Supersedes:
None**HP MODEL 5345A ELECTRONIC COUNTER****All Serial Prefixes****FAILURE TO RESPOND PROPERLY TO A SERIAL POLL
BY A SERIES 200 CONTROLLER**

This is how the modification appears on the schematic of the A12 board:

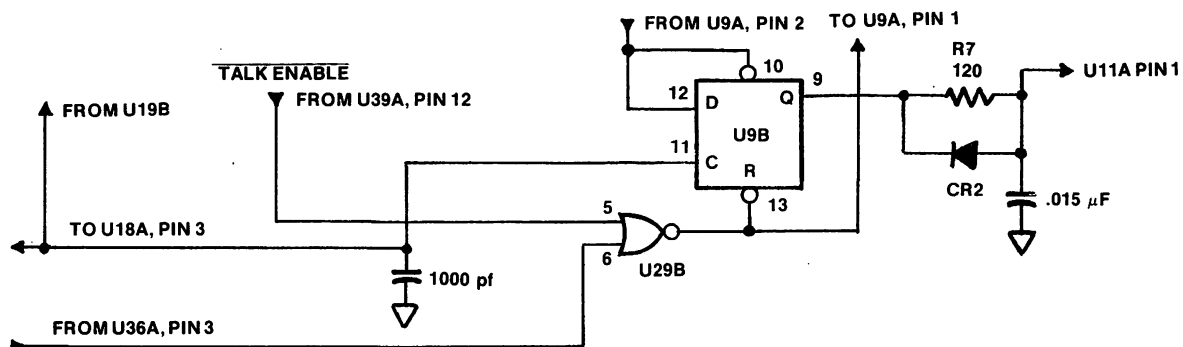
A modification is necessary in order to allow the HP 5345A Option 012 counter to respond properly to a serial poll by a Series 200 controller. When polled by a Series 200 controller, the HP 5345A Option 012 will intermittently hang up the HP-IB and cause the handshake operation to cease. This is due to the controller bringing ATN false (+5 volts, negative true logic) before the HP 5345A can internally process the RFD false-to-true transition between the Serial Poll Enable (SPE) byte and the status byte transmission. The ATN line must be false to signify the presence of a data byte rather than a command byte on the HP-IB.

A race condition is set up at the clock (pin 11) and reset (pin 13) inputs to U9B on the A12 board. Clocking must occur after the reset signal for the proper logic levels to drive U11A which eventually drives the DAV line via U9A. Both the clock and reset inputs to U9B are derived from the ATN signal. A 1000 pf capacitor, HP Part Number 0160-4040 should be connected from pin 11 of U9B to pin 7 of U9B in order to delay the clock until after the reset has occurred.
